SUBJECT: SUMMARY OF CONFERENCE CALL MEETING TO DISCUSS OPEN ITEMS AND
OUTSTANDING REQUESTS FOR ADDITIONAL INFORMATION RESPONSES
RELATING TO DTE ELECTRIC COMPANY'S FERMI 3 COMBINED LICENSE
APPLICATION

Subject: **Response to NRC RAI Letter No. 363 Related to ESBWR Design Certification Application – DCD Tier 2 Section 3.8 – Seismic Category I Structures; RAI Number 3.8-94 S05**

RAI Number 3.8-94 S05

Figure 3.8-94(1) Input Motion Spectra and RFB SSI Fundamental Frequencies

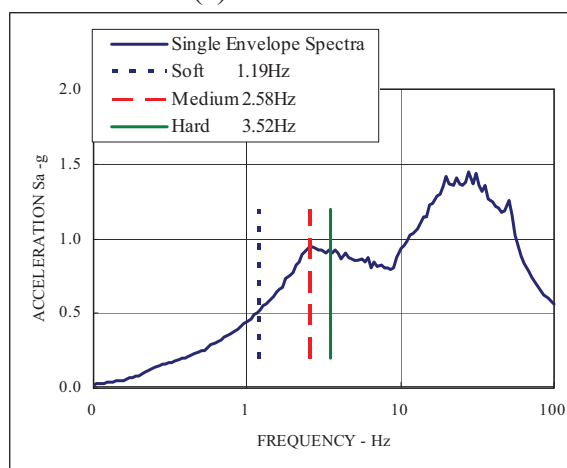
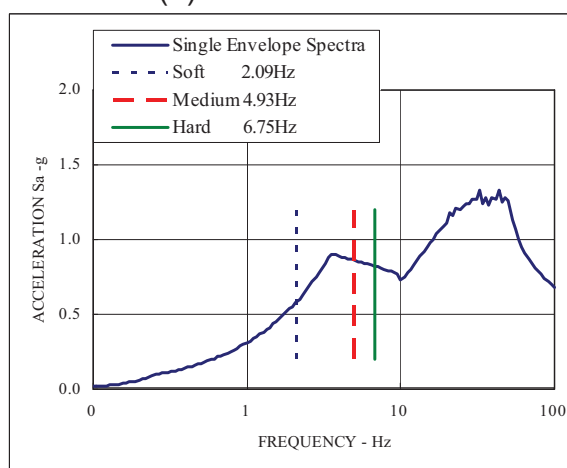
- (2) GEH is requested to explain why it is acceptable to use a linearly interpolated value for the soil bearing capacities between the three sets of values (soft, medium, and hard). Using the information presented in Figure 3.8-94(1) (c) of the response (as an example), this would underpredict the required bearing capacity.*

In accordance with NRC RAI 3.8-94, Supplement 2, Figure 3.8-94(1) (c), the vertical input response spectrum peaks at 3.57 Hz in the frequency range between 2.09 Hz for the soft site and 4.93 Hz for the medium site. This peak vertical frequency is 73% of the vertical SSI fundamental frequency at the medium site.

Applying the same frequency ratio to the horizontal SSI frequencies of the medium site, the horizontal SSI fundamental frequencies for the 3.57 Hz vertical frequency site (termed "intermediate site" hereafter) are found to be 2.14 Hz and 1.87 Hz in the NS and EW directions, respectively. The corresponding spectral accelerations are 0.85g, 0.76g and 0.9g in the NS, EW and vertical directions, respectively, and the corresponding ratios to the medium site spectral accelerations are 0.91, 0.8 and 1.05, as shown in Figure 3.8-94(2).

Figure 3.8-94(19) FRS (Compared with the DAC3N) – RSW Top Y

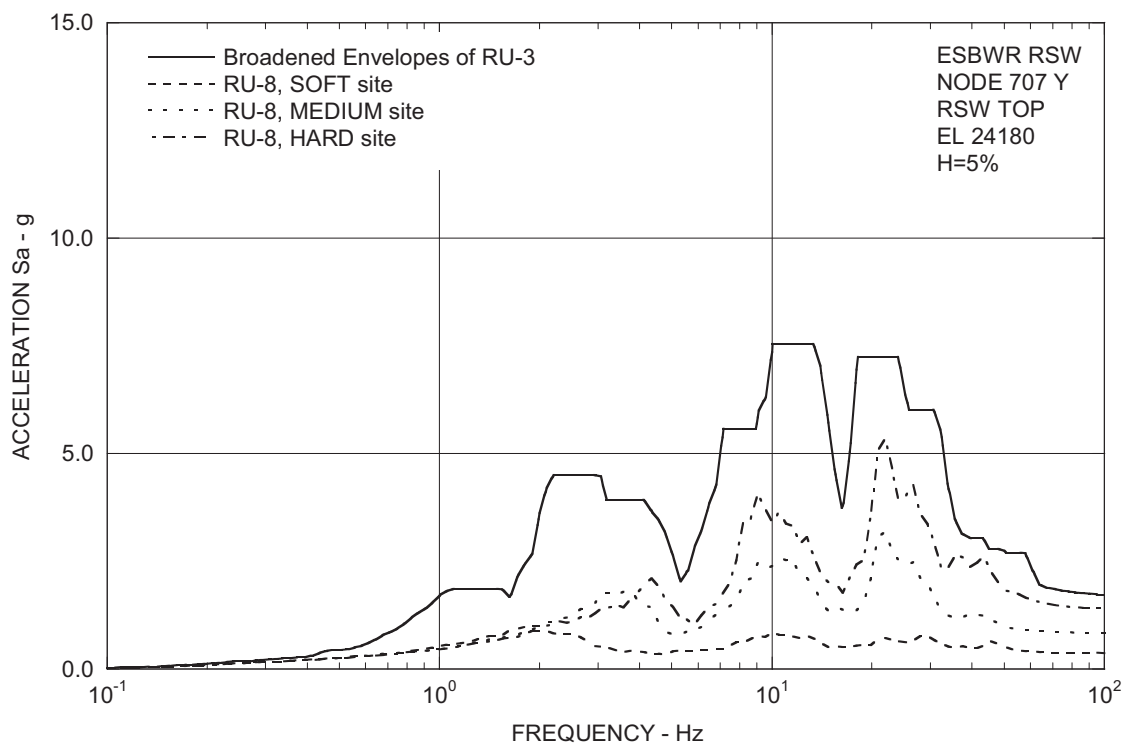
- I) In several of the enveloping floor response spectra (e.g., Figures 3.8-94(19), (20), and (22), the staff noted that “valleys” exist between successive peaks in the low frequency region, up to approximately 5 Hz. If the spectral peaks are influenced by site conditions, it is the staff’s position that these “valleys” should be filled-in to accommodate the expected variability in site shear wave profiles that may be encountered for this generic design. GEH is requested to provide an explanation why these valleys have not been filled-in.*

- I) Sufficient levels of conservatism are already built into the design floor response spectra in the form of enveloping and peak broadening the results of a sufficient number of generic sites under a bounding Certified Seismic Design Response Spectra (CSDRS) ground input motion. To provide additional margins for sites that might have predominant SSI frequencies at the spectral valleys, the spectral valleys of the site enveloping floor response spectra are further filled-in for the generic design floor response spectra. As an example, the original enveloping floor response spectra at the Vent Wall top, which is the same location as shown in Figure 3.8-94(18), is shown in Figure 3.8-94(43) together with its respective enveloping floor response spectra having the spectral valleys filled-in. The site enveloping floor response spectra in DCD Tier 2 Subsection 3A.9.2 will be replaced in Revision 6 with enveloping floor response spectra having the spectral valleys filled-in. DCD Tier 2 Subsections 3A.8.7 and 3A.9.2 will be revised in Revision 6 for clarification with regards to the spectral valleys being filled-in.

Figure 3.8-94(40) RB/FB Layered Site Soil Case RL-2, Time = 7.810 sec

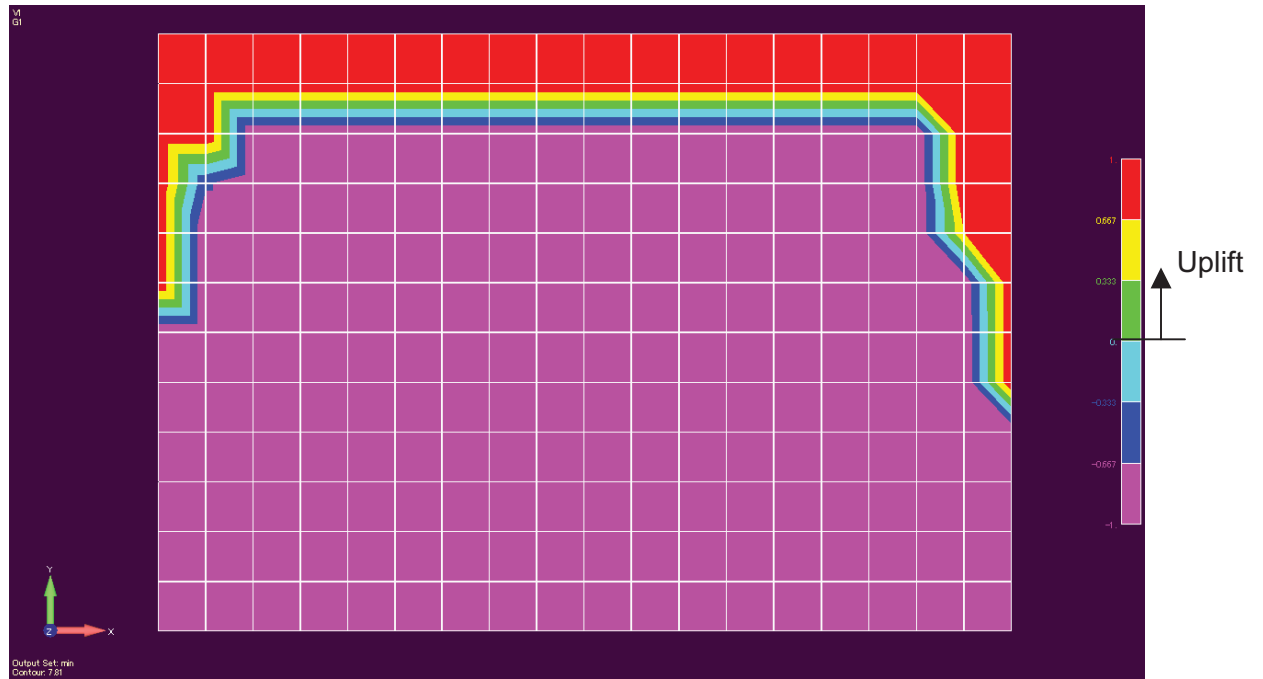
Lastly, provide the magnitude of the uplift calculated using the EBM so that a comparison can be made with the extent of implied uplift (i.e., tensile basemat/soil interface loads) shown in Figure 3.8-94(40) of the RAI response. The above requested

The SASSI results for the RB/FB layered site soil Case RL-2 are examined for the extent of maximum uplift when the bearing pressure reaches maximum in combination with dead loads and buoyancy. As shown in Figure 3.8-94(40), the extent of uplift is not extensive and a large portion of the basemat remains in contact with the soil.

Figure 3.8-94(44) Basemat Configuration and Pressure Distribution

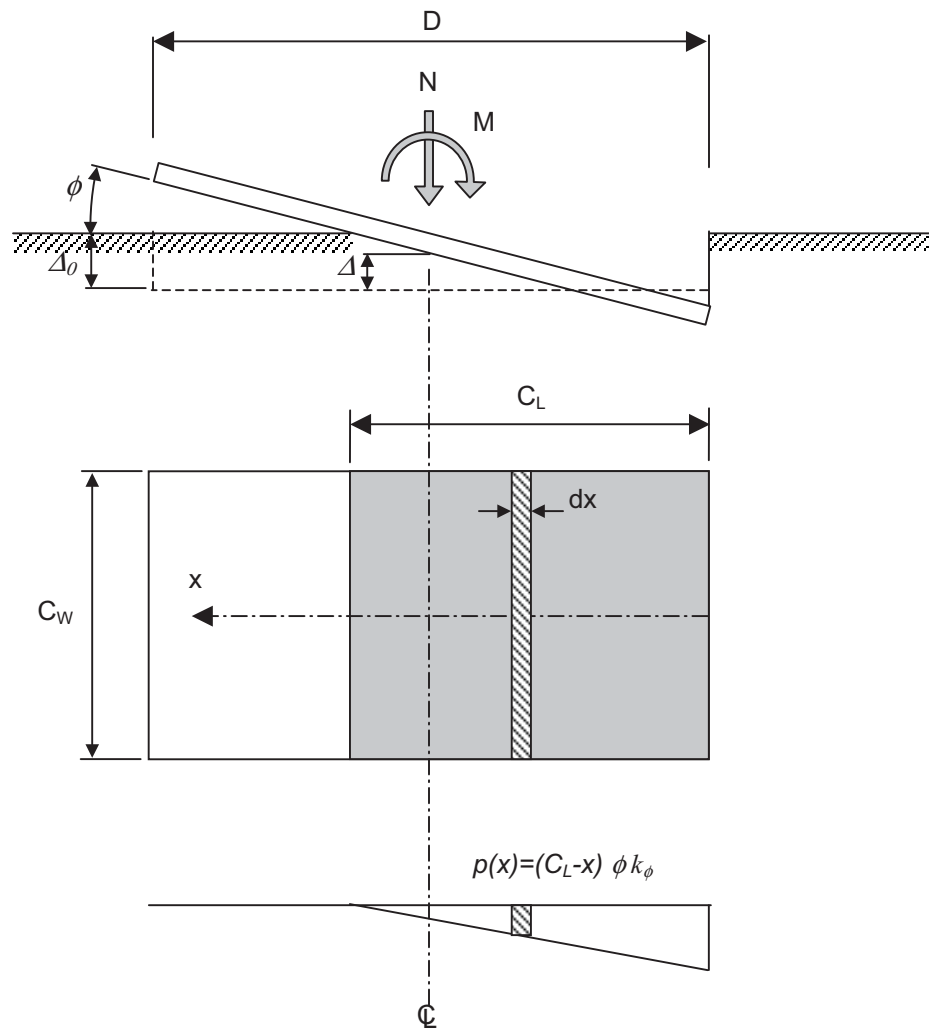
- 1. The formulation presented in the referenced paper is applicable to circular rigid foundations. Provide justification for use of these formulations for the rectangular foundations for ESBWR. Otherwise, if a new set of formulations were derived for the rectangular foundations at ESBWR, provide the basis for these new formulations.*

Figure 3.8-94(44) shows the configuration of a rigid rectangular basemat in the uplifted position. The basemat is considered to be supported by a set of uniformly distributed compression (no tension) vertical soil springs having stiffness k_ϕ per unit area, which are determined by the following:

Referring to Figure 3.8-94(44), the foundation vertical force N and the overturning moment M in the uplifted position can be related to soil pressure $p(x)$ and the foundation contact length C_L .

Figure 3.8-94(46) Soil Pressures due to Moments in Two Directions

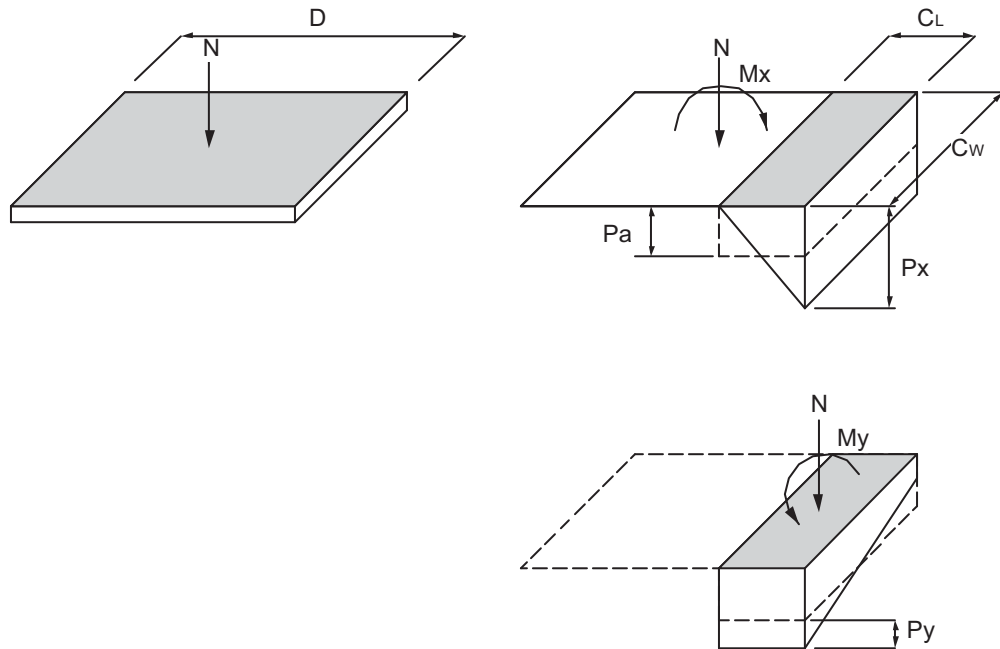
- 3. Confirm that the "Contact Width – CW" used in the formulations for bending about the other (perpendicular) horizontal axis corresponds to the full width of the foundation. If this is the case, then explain why the full width is utilized. Has it been determined that no uplift is possible for rotation about the other horizontal axis or that the uplift about both axes do not occur at the same time? The staff notes that if there is uplift possible for rotation about the other horizontal axis, this might cause higher soil bearing pressures than those calculated in the RAI response.*

- (3) To account for potential uplift due to rotation about the other horizontal axis, two separate cases, a) M_x using MEB together with M_y with full width C_W and b) M_y using MEB together with M_x with full width C_W , were considered as illustrated Figure 3.8-94(46). The final soil bearing pressure is the envelope results of the two cases.
